**MANHATTAN COMMUNITY BOARD SIX**

Mark Thompson, Board Chair, requested Mr. Fred Arcaro, Chair of the Board’s Public Safety, Environment & Transportation Committee, to produce the following comments based upon a meeting held on November 22, 2011 with representatives from the Department of Environmental Protection (DEP), Department of Design & Construction (DDC) and the Department of Transportation (DOT) to discuss the trunk water main route and the construction, for shaft site 33b of the Third Water Tunnel.

Mark Thompson, Chair of Manhattan Community Board Six (“CB6”), requested that Fred Arcaro, Chair of the CB6 Public Safety, Environment & Transportation Committee, summarize CB6’s conclusions regarding the second water main construction route. The attached report was issued earlier, but this cover memo recaps that report’s conclusions and includes additional information.

NEW YORK CITY DEPARTMENT OF ENVIRONMENTAL PROTECTION  
PROPOSED SHAFT 33B TO CITY WATER TUNNEL NO. 3  
STAGE 2-MANHATTAN LEG  
WATER MAIN CONNECTIONS

Ex. #1

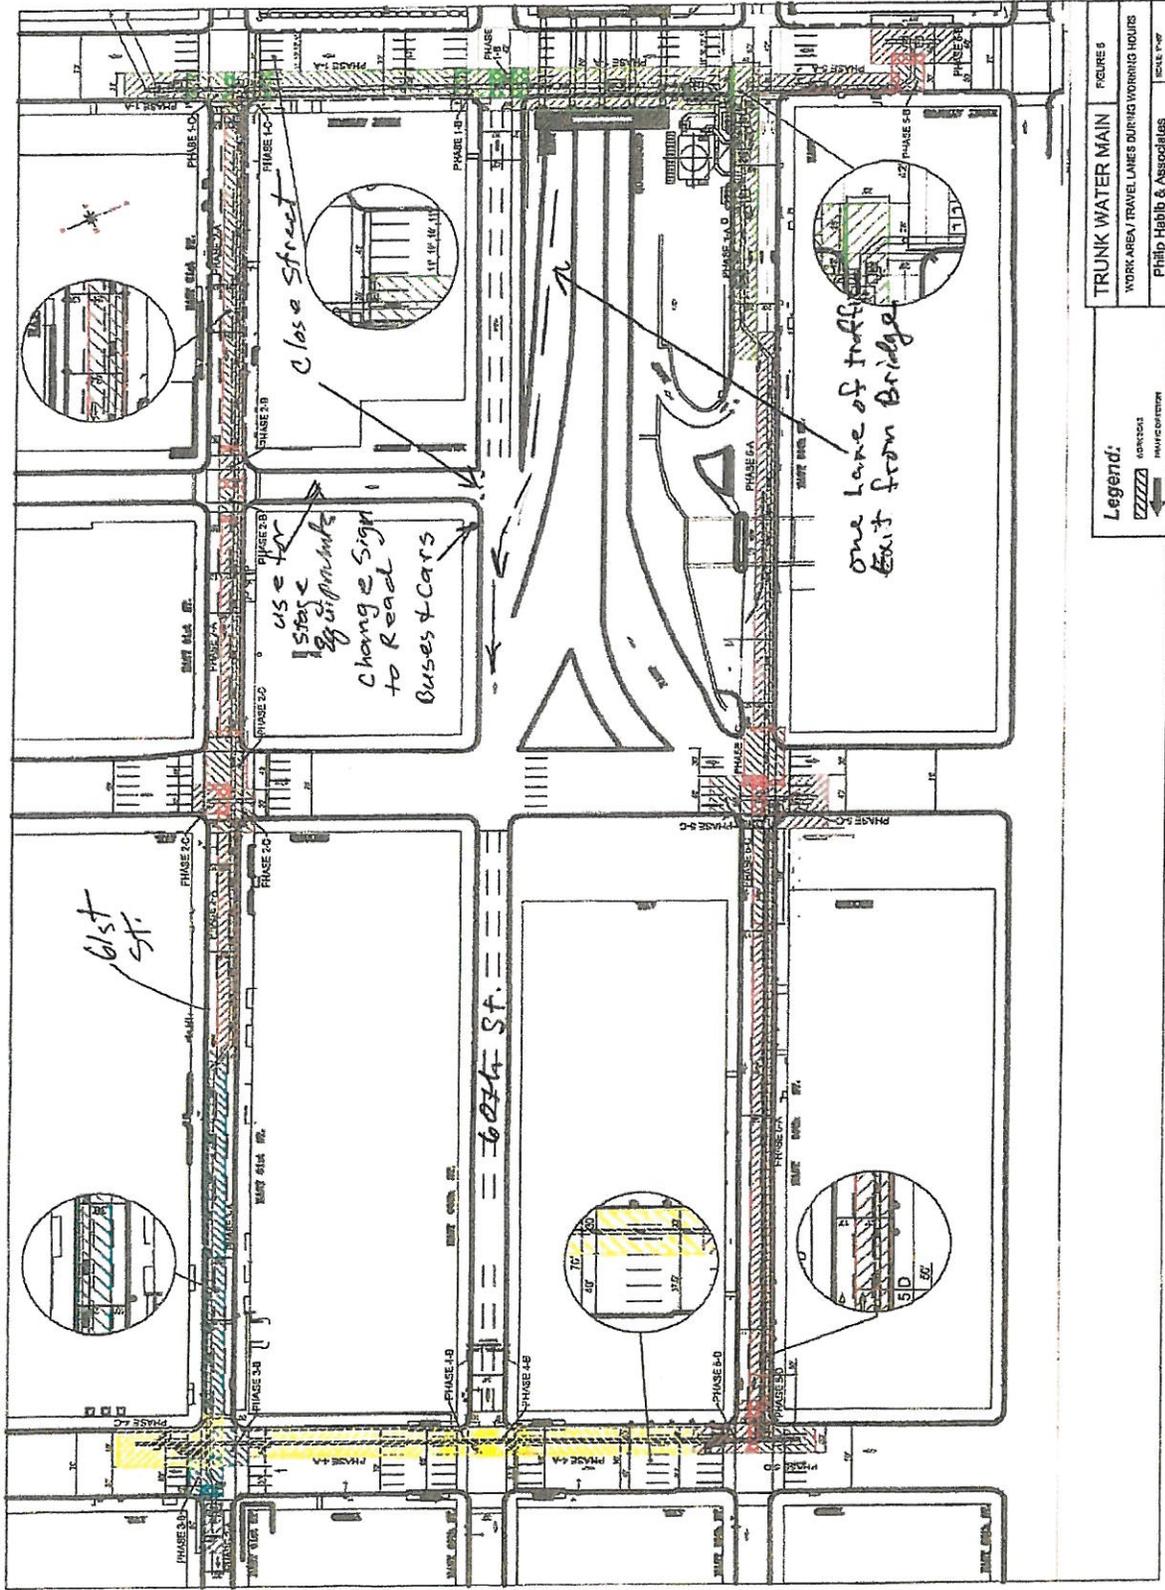
At the meeting, DEP stated that the Philip Habib traffic study prepared for the NYC Department of Design & Construction is flawed. Being that the Community Board, an official New York City agency, was not involved in any of the agency planning meetings, as required by the NYC Charter, Community Board Six is requesting a thorough explanation of the basis of why DEP has claimed that the study is flawed and would like to see all data used to determine the use of E. 58<sup>th</sup> Street, and requests that a new traffic study be conducted for E. 58<sup>th</sup> Street.

- Philip Habib & Associates was chosen by DEP because it is a respected traffic consulting firm that has worked for public agencies on numerous occasions. The study states two lanes - rather than three - would suffice for general traffic use. Therefore, there would be no need for plating and re-plating of the water main trench. This would greatly reduce the time and cost for construction of the water main.
- As background information, according to DEP’s EIS (2008), Chapter 4 (Traffic and Parking) Fig. 4.9-7, traffic volume for E. 58<sup>th</sup> Street between First and Second Avenues, DEP’s preferred route at AM peak hour (no build) is 726 vehicles (see

Ex #3

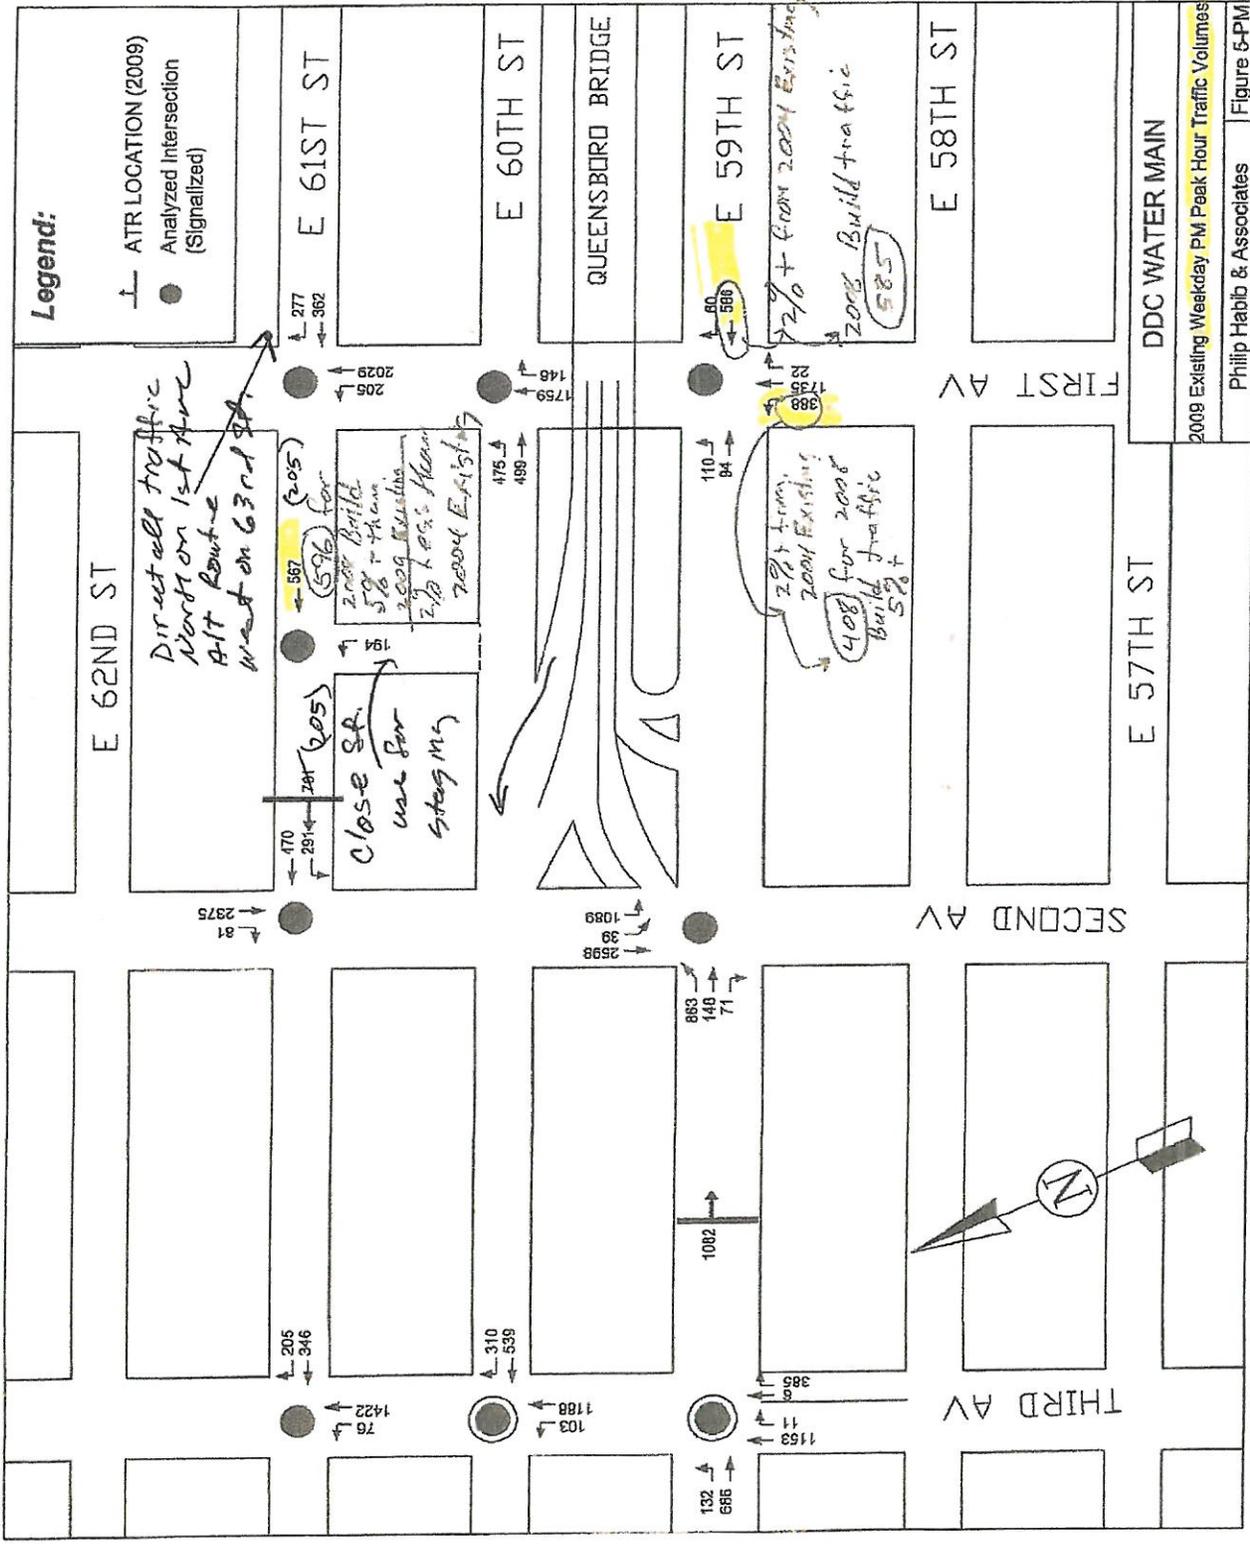
- Change the DOT street sign at the northwest corner of the Midblock Street and E. 60<sup>th</sup> Street from “No Left Turn except Buses” to “Left turn for Cars and Buses”; allowing vehicles exiting the 59<sup>th</sup> Street Bridge needing to go west to use E. 60<sup>th</sup> Street instead of E. 61<sup>st</sup> Street. (See Exhibit #3).

- Since the midblock street would be closed to traffic from the one lane bridge exit (see Exhibit #14 marked up) traffic could be directed to use E. 60<sup>th</sup> Street to go west once the sign has been changed. The traffic volume on E. 61<sup>st</sup> between midblock and Second Ave. would then be 579 during peak, and would be maintained past the midblock street. This reduced traffic volume would be less than on E. 58<sup>th</sup> Street which is 726 during AM peak periods. See Exhibit #2, #4 and #13 marked up.

2009 Existing Weekday PM Peak Hour Traffic Volumes  
Philip Habib & Associates | Figure 6-PM

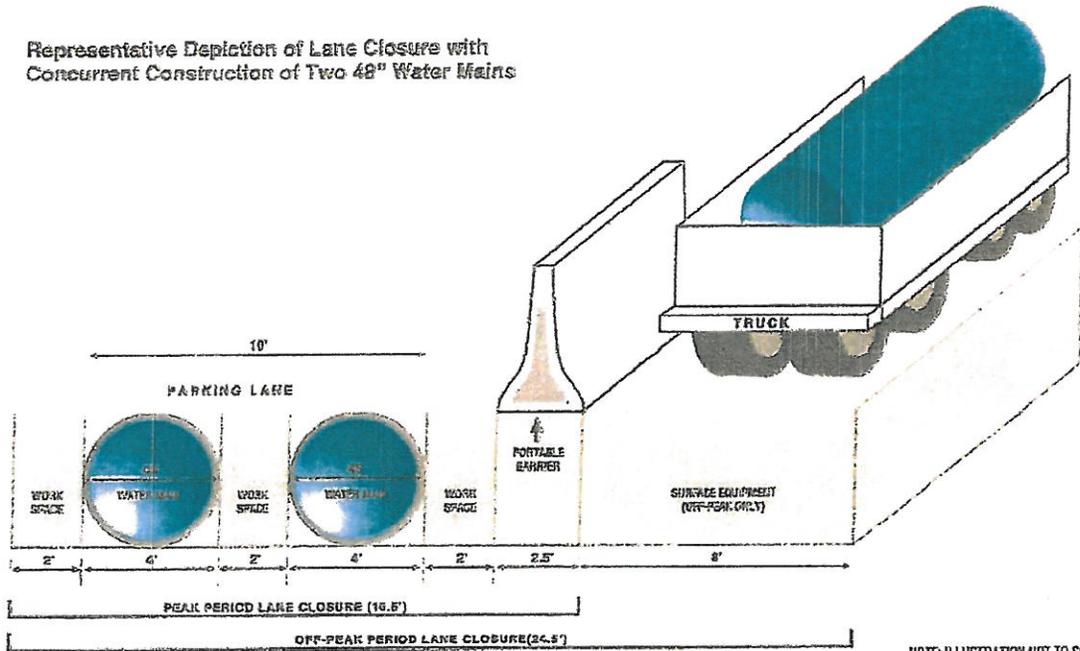
Exhibit #1). The alternate route could be on E. 61<sup>st</sup> Street between First and Second Avenues. In 2009, Philip Habib & Associates did a traffic study for E. 61<sup>st</sup> Street between First and Second Avenues depicting weekday AM peak hours. The study found that traffic was 579 vehicles per hour between First and midblock, and between the midblock and Second Avenue the traffic volume is 819 vehicles per hour (see Exhibit #2).

- At the northeast corner of E. 61<sup>st</sup> Street and First Avenue, place an Alternate Route sign directing all westbound traffic to use E. 63<sup>rd</sup> Street. See Exhibit #5

- This diversion of traffic would reduce traffic flow on E. 61<sup>st</sup> Street between First and Second Avenues to approximately 215 and between Second and Third Avenues and to approximately 389 during AM peak hours. See Exhibits #2 & #5

*Ex # 6*

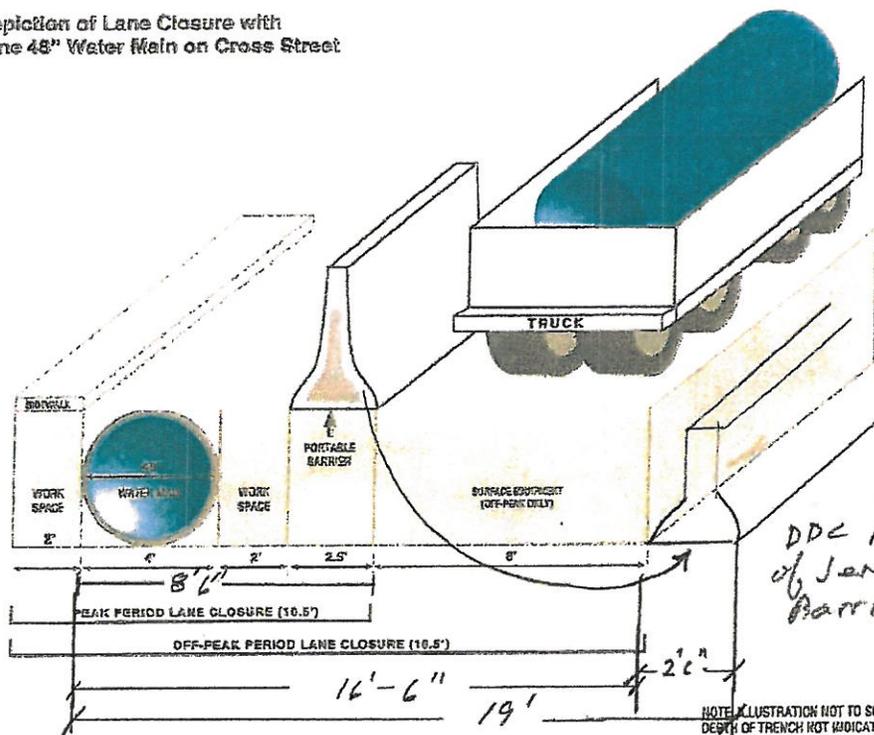
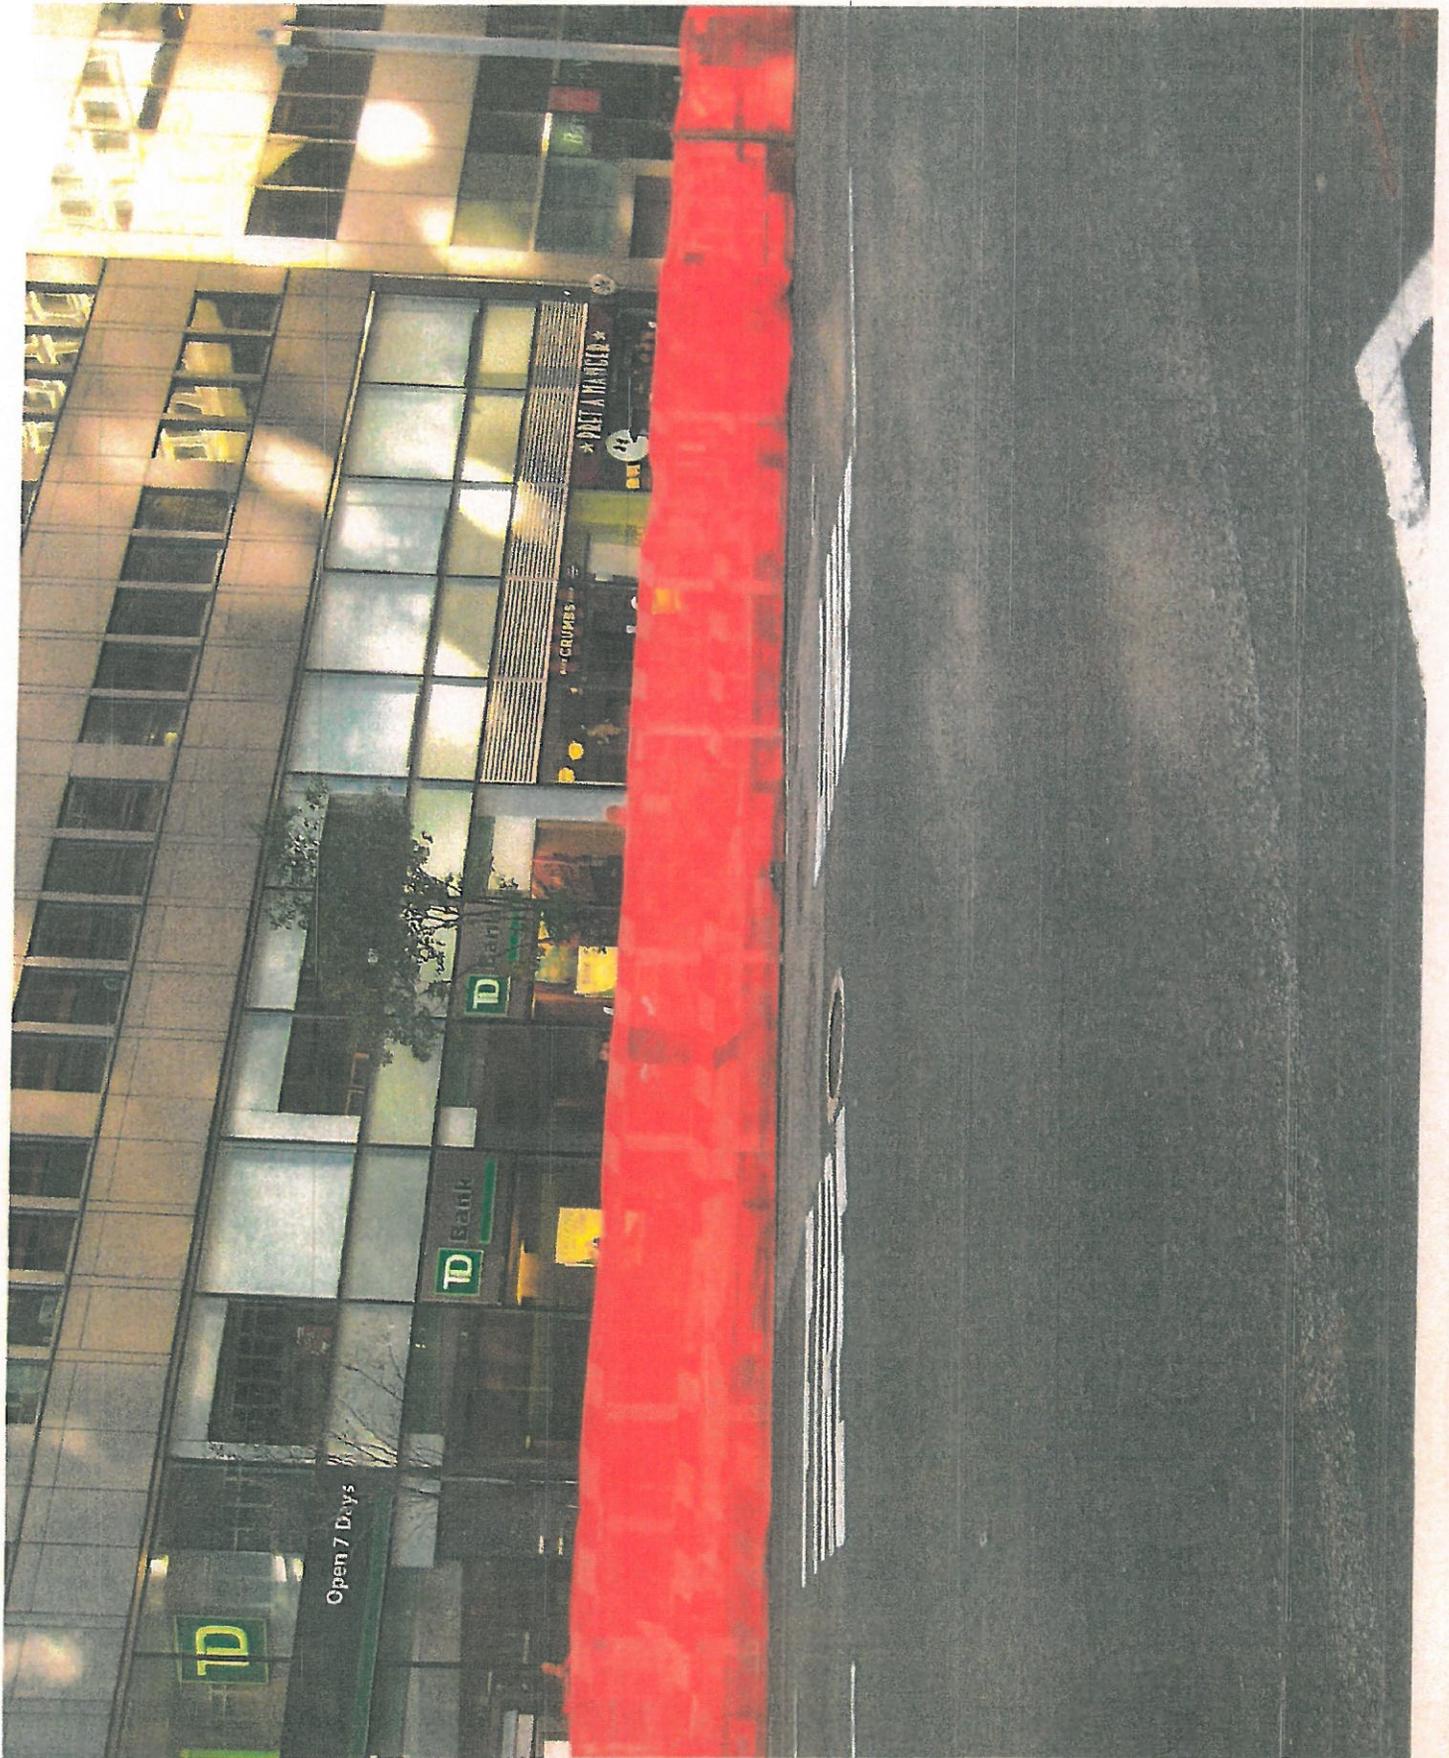
- Due to safety concerns, DDC requires that jersey barriers be located between the surface equipment vehicles lane and traffic lane to provide storage of equipment or construction trucks; resulting in the loss of one traffic lane during off-peak hours and leaving only one lane for general traffic. This requirement seems to be inconsistent with previous DDC practices. See Exhibit #6

- The above unnecessary requirement would consume two lanes for general traffic.
  - This requirement is inconsistent with DEP's EIS chapter 5, Fig. 5.1-4 for one 48" water main, which requires a total of 16'6" of street space during off-peak hours. This space requirement would put the jersey barriers between the water main construction trench and 8' surface equipment lane. See Exhibit #6.

*DDC placing of Jersey Barriers*

Ex #8

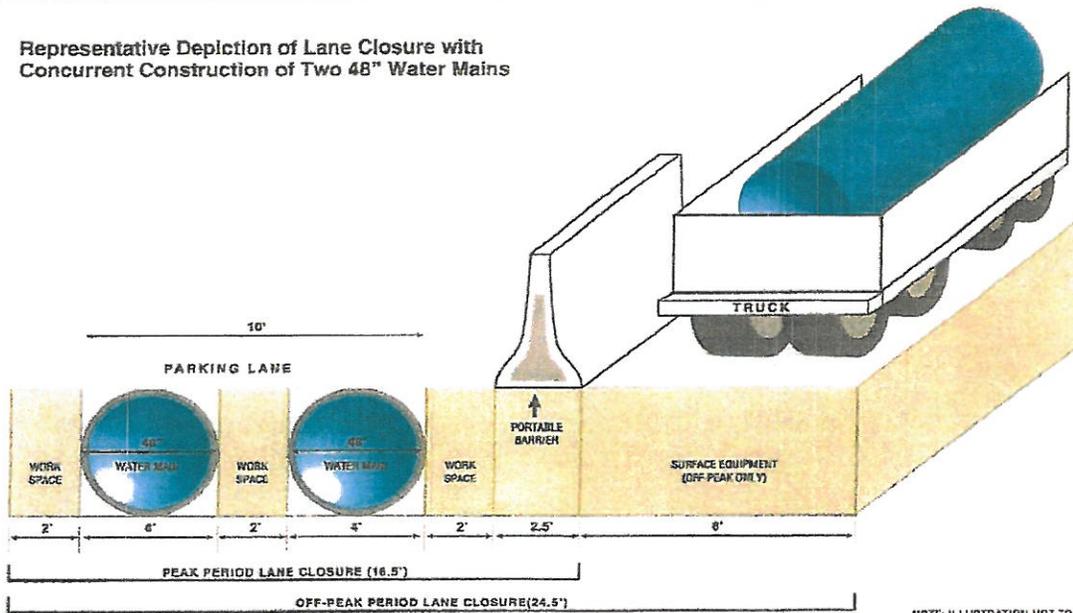
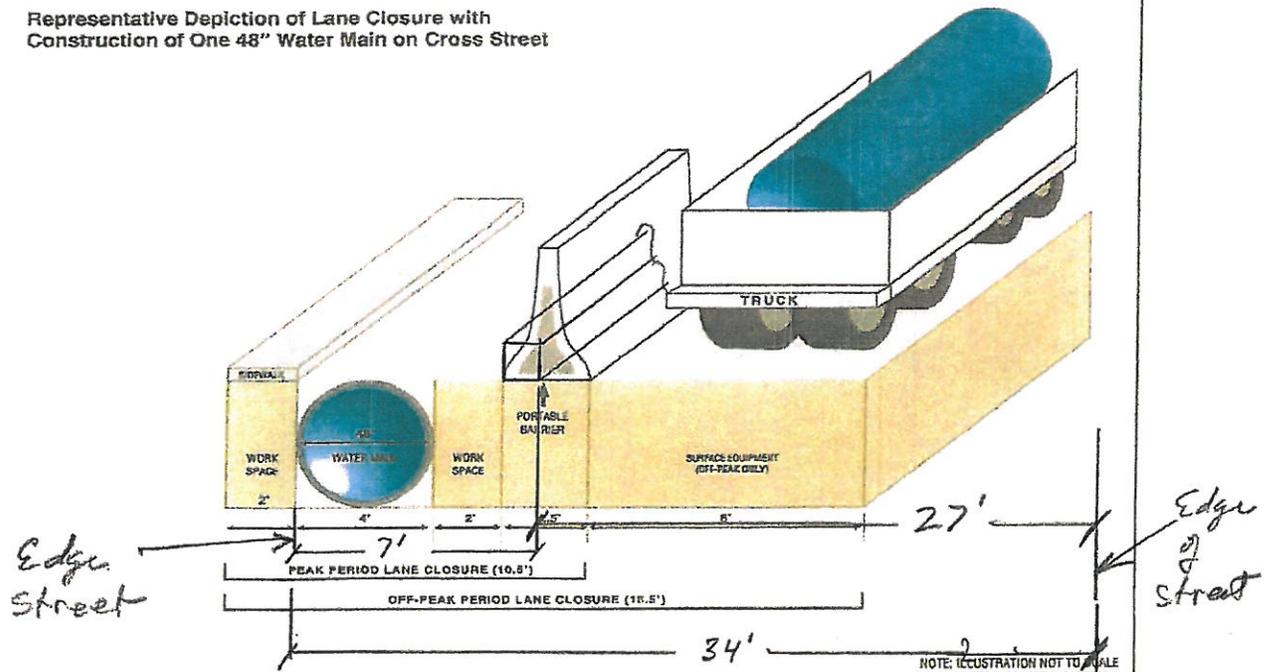
- If DDC would use 1' x 1' x 10' long wooden beams (used in many road construction projects; see Exhibits #7 and 8) instead of 2'6" wide jersey barriers then 1'6" of roadway would be gained for general traffic, resulting in a total of 27' of additional street space during peak hours. Having an additional 27' would be enough for three 9' wide lanes, one foot less than required by DOT for permanent lane installation requirement. See Exhibit #8 marked up
